Addendum 3
File # 18-0024

**Project: Pre-Insulated Pipe, Fittings, Valves and Accessories for Superior Street
Project – Phase 1 and 2**

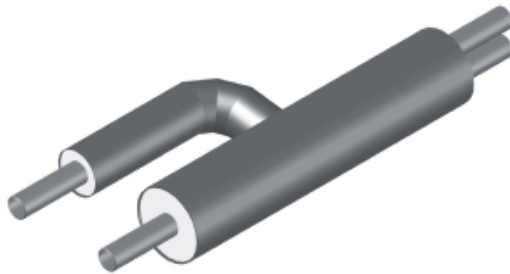
6. Please clarify what exactly is required for items 225719 and 225720. We are not clear on this. Is this a Y-type transition piece from 2 single pipes to the twin pipe similar to what is pictured here?

Yes
